**PLANNING COMMISSION SITE PLAN REVIEW SHEET
CONDITIONAL USE SITE PLAN APPROVAL**

CASE NUMBER: SPC-2012-0027C **PC DATE:** December 11, 2012

PROJECT NAME: Girls School of Austin

CITY OF AUSTIN – PLANNING AND DEVELOPMENT REVIEW DEPARTMENT
SITE PLAN APPLICATION – MASTER COMMENT REPORT

SHEET
CS101
8 OF 24

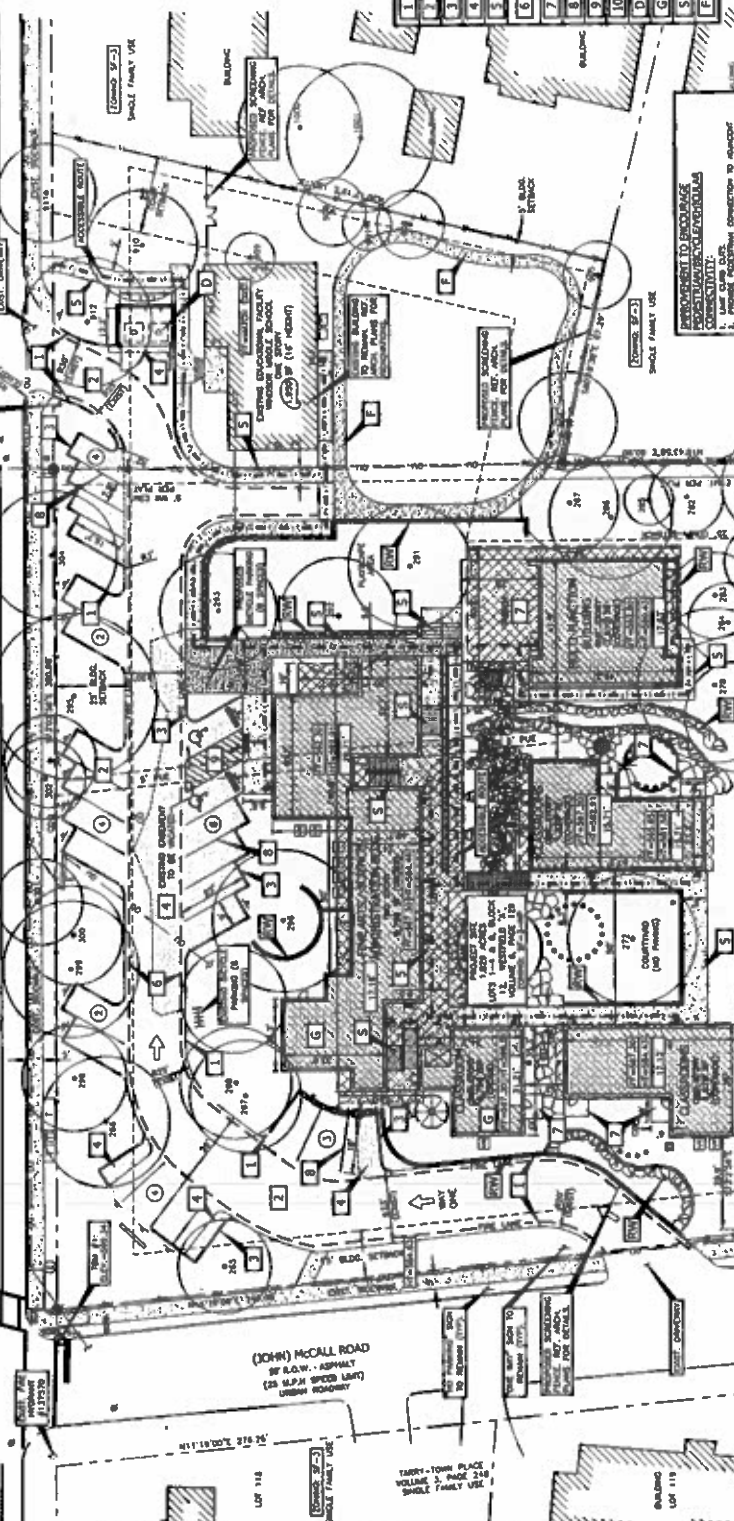
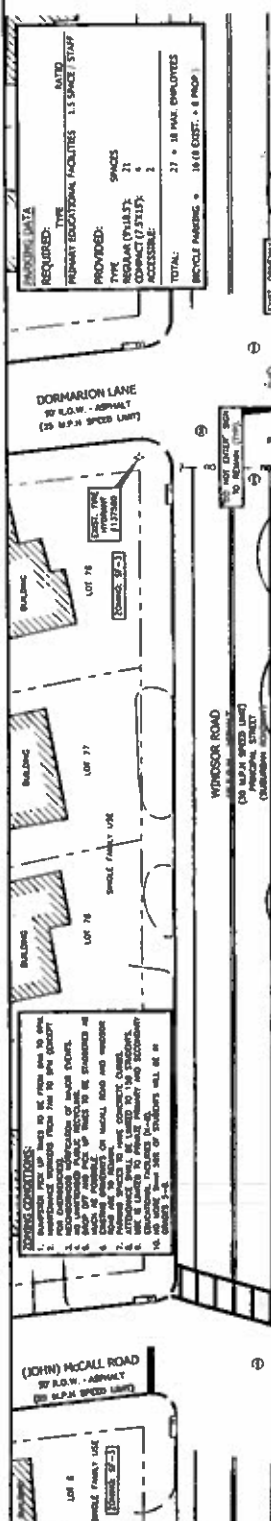
SP 10. Please all existing and proposed structures. Please add a few more dimensions to the fine arts building and verify the gross floor area for this building, and the total square footage of all buildings on the site. Gross floor area is the total enclosed area of all floors in a building with a clear height of more than six feet. Parking facilities, driveways and airspace above the atria ground floor are excluded. Please verify additional staff is required for the new buildings.

U1. Please clarify where the gross square footage for the Fine Arts Building is located.

U2. I still have some problems rectifying the calculations with what is shown on the site plan, Sheet CS101. Please call me and go over the building square footages with me.
